Fish Passage Plan (FPP) Change Request Form

| Change Form # & Title: | 16JDA001 – Two AWS Turbine Operation for SFL |
| Project: | JDA |

FPP SECTION: JDA 4.3.3.1. – Adult Fish Facilities - Non-Routine Maintenance

Figure 1. Schematic of the JD-S fishway with the location of the AWS turbine pumps (brown) and the locations of potential operational measures described in the text.

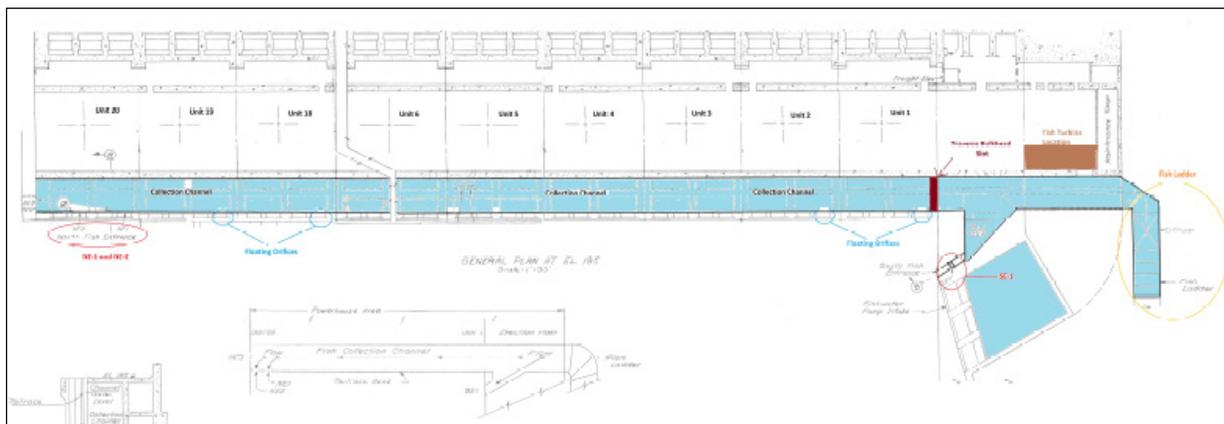
JUSTIFICATION FOR CHANGE: John Day-South (JD-S) fishway has an auxiliary water supply (AWS) powered by three “turbines” which feed water to the entrance area of the JD-S ladder (Figure 1). Each turbine design is complex and consists of a turbine, gear box, and the pump itself. The bearing of AWS turbine #1 was discovered to have failed by JD Maintenance on 2/08/16 during an “in depth” winter inspection, which occurs every few years. Inspection of turbine #2 started on 2/17/16 and it was discovered that its pump’s lower bearing was also in a failed condition. However, JD Maintenance has been working on retrofitting a spare fitting from turbine #3 into turbine #2 temporarily. Therefore the Project believes they will start the fish passage season on 1 March with one functioning AWS turbines. It’s unknown how long repairs to turbine #1 will take. Turbine #2 is awaiting parts and should return to service 17 March.

With only two AWS fish turbines available, JDA fisheries proposes to operate the S fish collection channel without floating orifice gates at units 18 & 19. This configuration is identical to South ladder operation during the turbine 3 rehab project from 2008-2011. Closing floating orifice gates at units 18 & 19 will give the project more operational flexibility running the remaining two AWS turbines at lower rpm’s while maintaining channel velocities and entrance differentials.

COMMENTS: March 10, 2016, FPOM – Fredricks is fine with the temporary operation in the MOC (16JDA02) but not ok with changing the FPP for something that needs to be prioritized for repair. Three workable pumps are necessary to maintain criteria.

4.3.3.1.a. South Ladder. If one of the three auxiliary water turbines fails, assuming all three turbines are being used to meet criteria, the output of the two remaining turbines will be increased to meet adult fishway criteria. The two floating orifice gates at units 18 & 19 may be closed to meet entrance criteria and will be coordinated through FPOM prior to closure. If a second turbine unit fails, the adult fish facility will be operated as follows until a fishway head of 1' is achieved:
